**Keeyask Generation Project**  
**Causeway to Borrow N-5 – Description of Repair**

Manitoba Hydro, in its delegated authority to manage construction of the Keeyask Generation Project on behalf of the Keeyask Hydropower Limited Partnership, is submitting the proposed repairs to the causeway to Borrow N-5. These modifications are in response to the high ice and water levels experienced in the winter of 2014/15 and the risk that a stable ice cover does not develop upstream of Gull Rapids in future years when construction is occurring. Manitoba Hydro is requesting that culverts not be re-installed in the causeway to Borrow N-5 (Map 1) and is including information regarding the repairs to the abutments.

Figure 1  
N5 Causeway South Abutment  
Enhancements

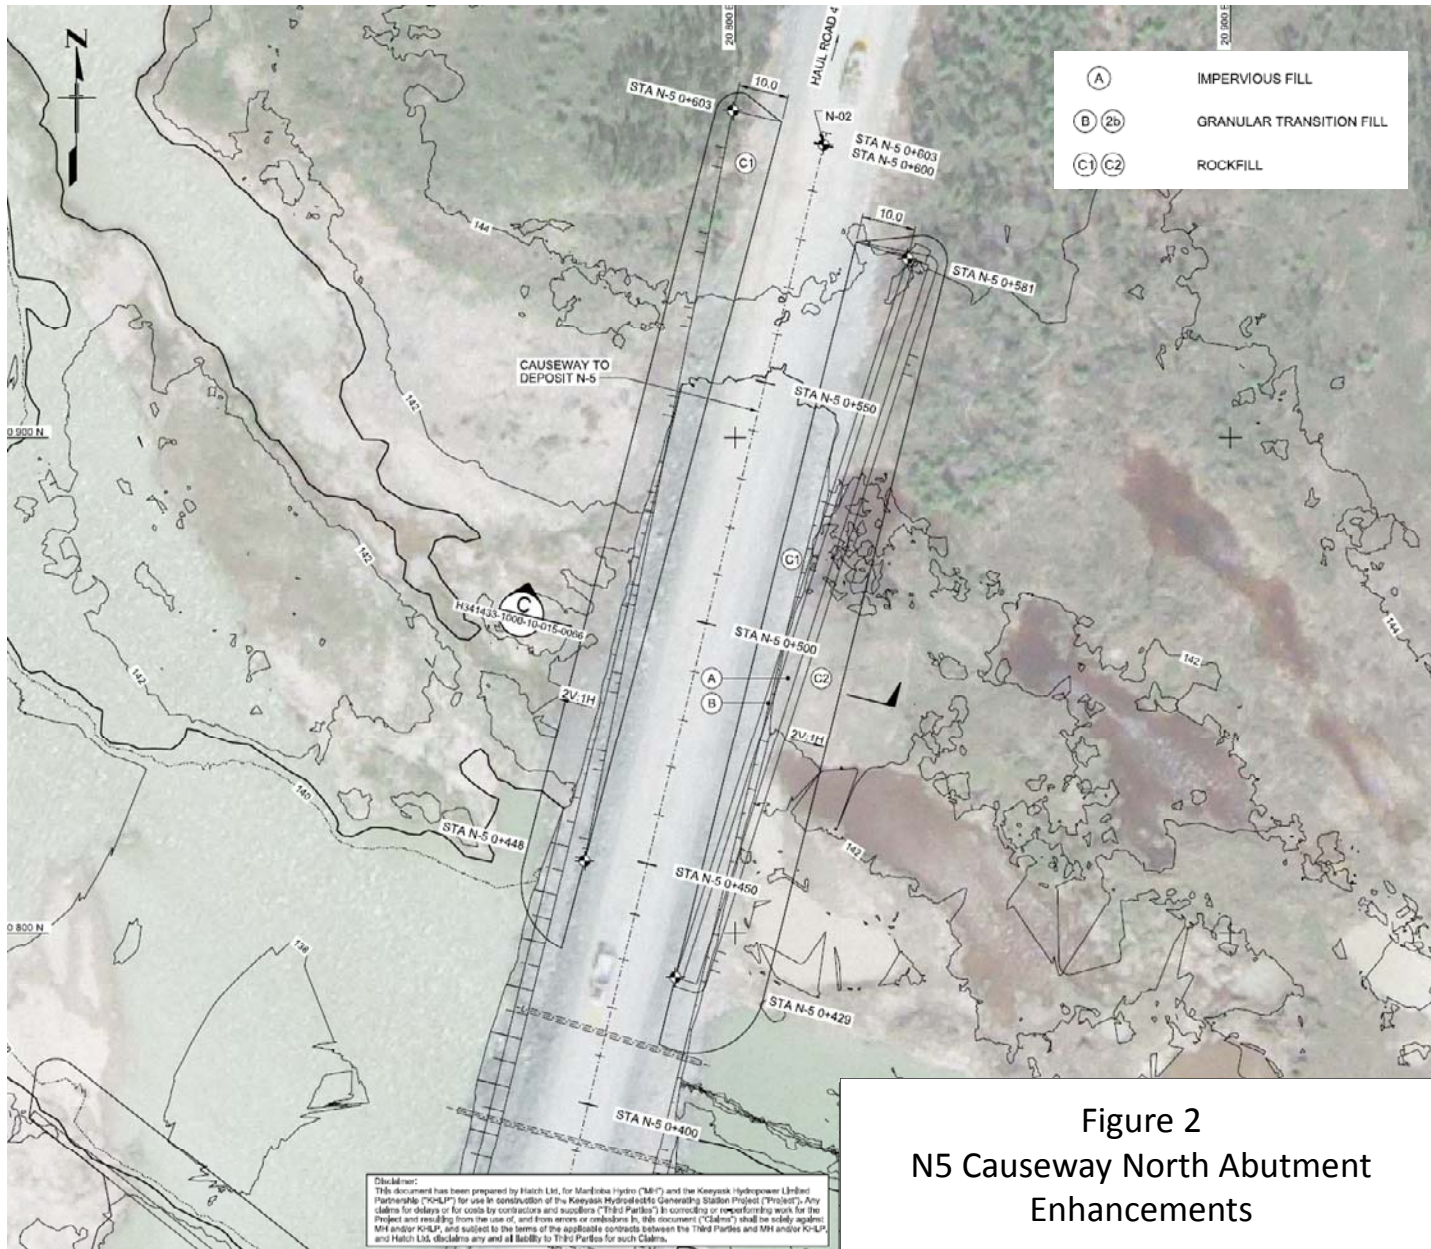
In order to prevent additional erosion of the south abutment and shore line the measures listed below will be implemented. These measures are shown in Figure 1.

- Granular and impervious material will be placed on the east side to reduce seepage through the abutment.
- A cut-off trenched filled with impervious material will be placed on the east side and will reduce

seepage through the abutment.

- Granular material will be placed on the west side of the abutment to prevent abutment soils from washing away.
- Rock fill will be placed along the shoreline to protect the newly placed granular and impervious material.

Figure 3  
G3 Causeway Abutment  
Enhancements

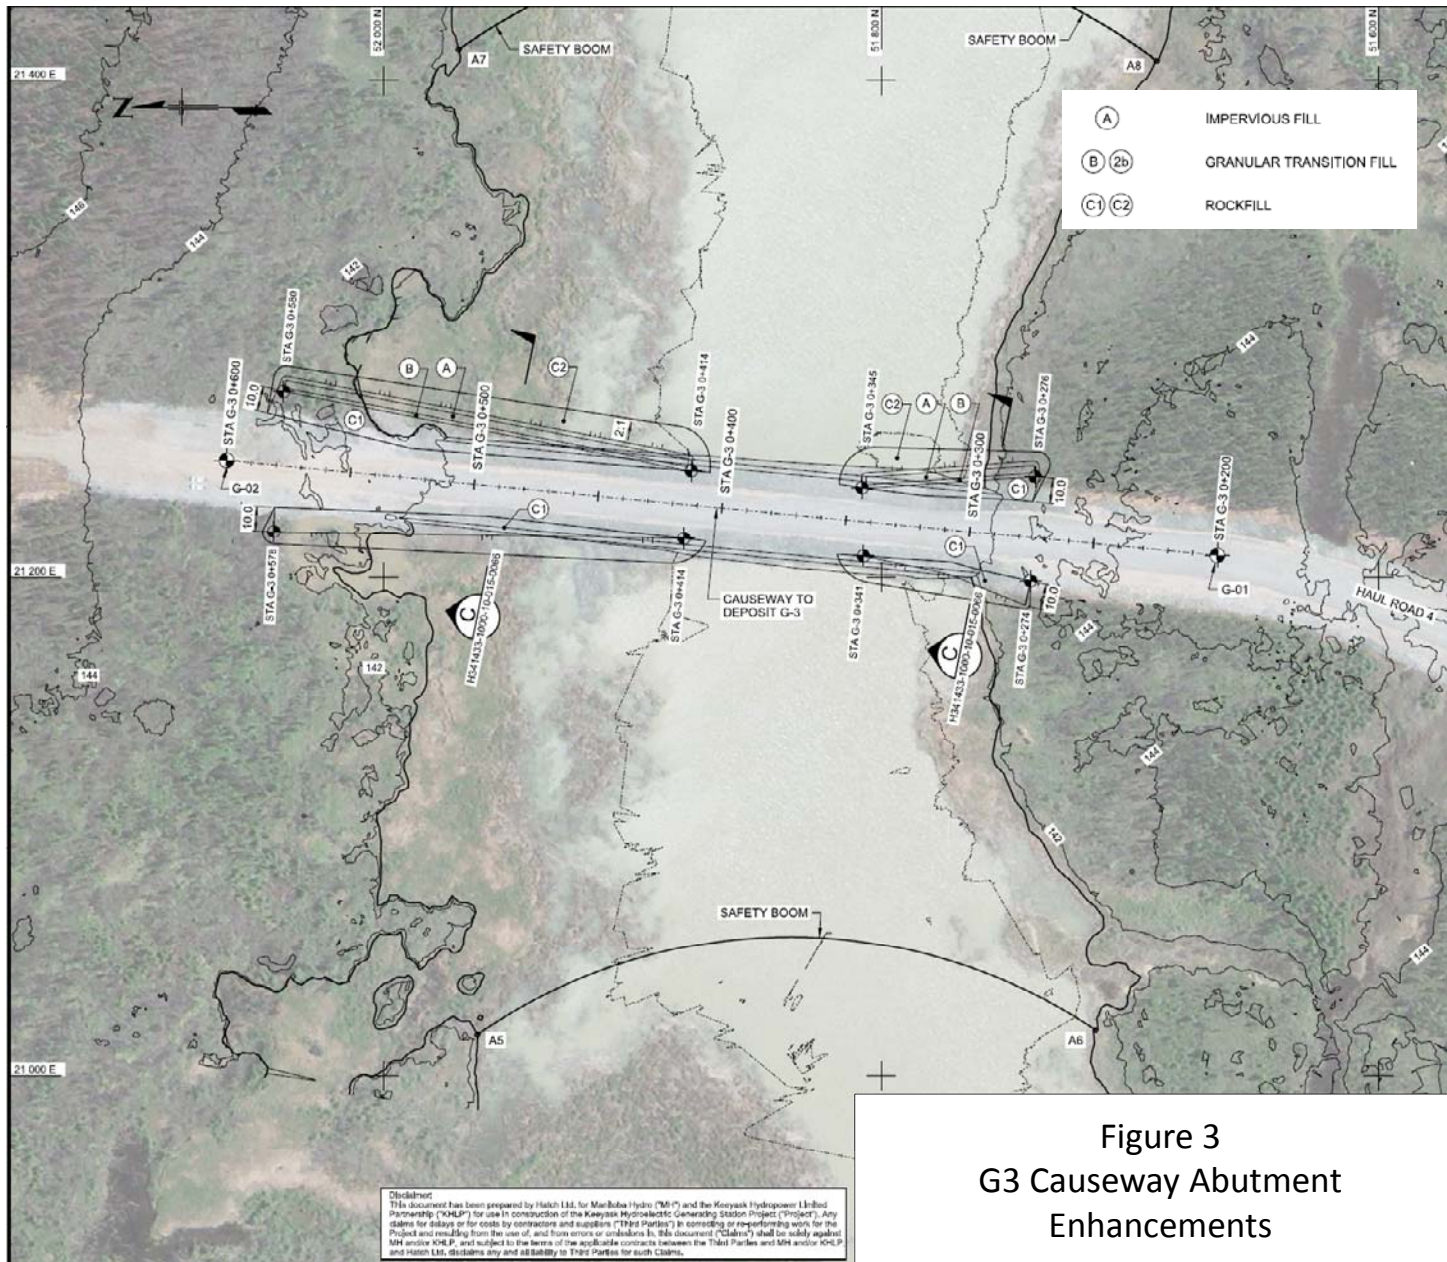
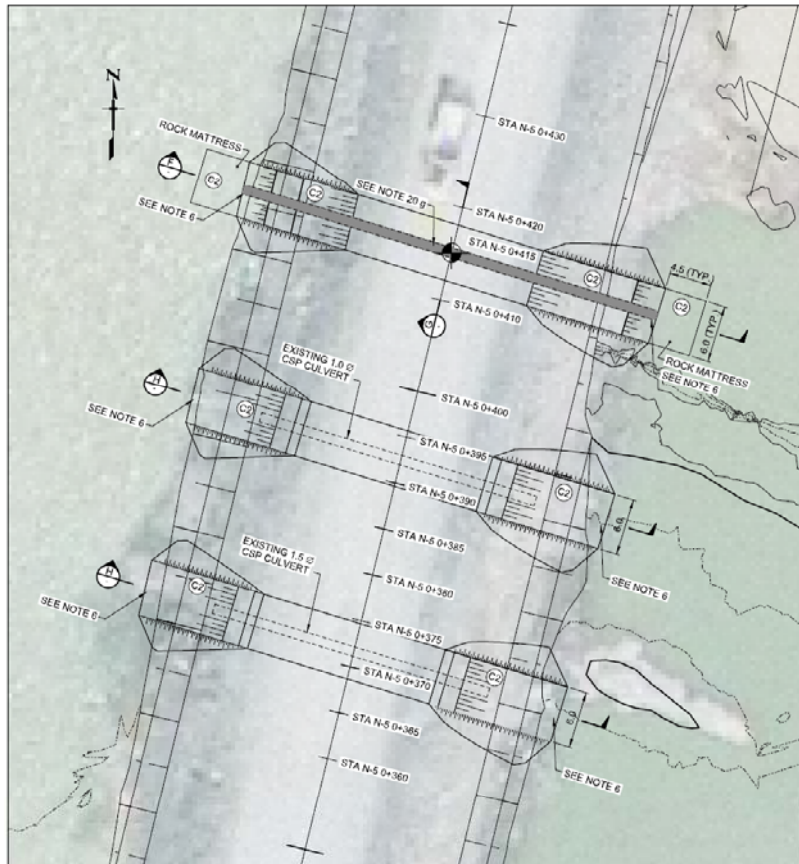
Measures are also being developed to prevent erosion at the north abutment of the causeway to Borrow N-5 and both abutments of the causeway to Borrow G-3. Imperious fill, granular material and rock fill would reduce seepage through the overburden material at the abutments. These are shown on Figures 2 and 3.

Figure 4  
N5 Causeway Culvert Removal  
& Capping Details

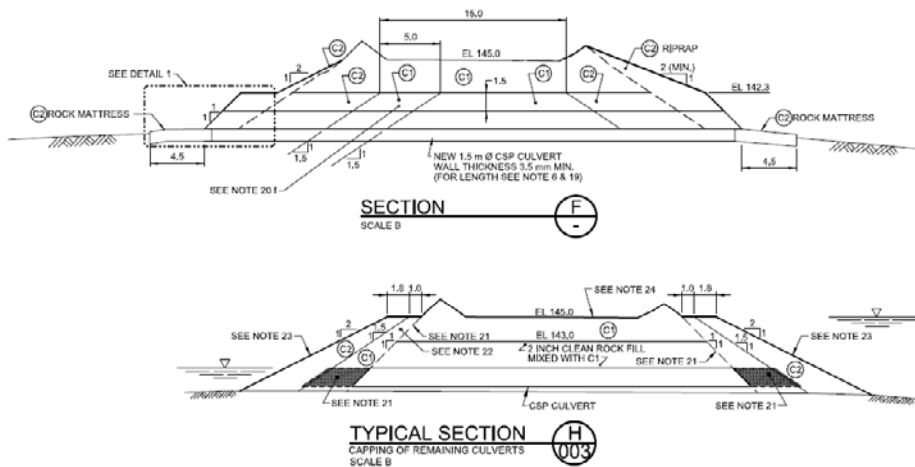
Capping the existing culverts would entail flattening each end of the culvert and covering with layers of Class 1, Select Class C1 and Class C2 rock fill as shown in Figure 4. The different layers of rock in the caps will be graded to prevent further erosion of material around the culvert and avoid development of sink holes. Much of the fine material washed out during the winter of 2014/15 which further reduces the potential for erosion at the culverts.
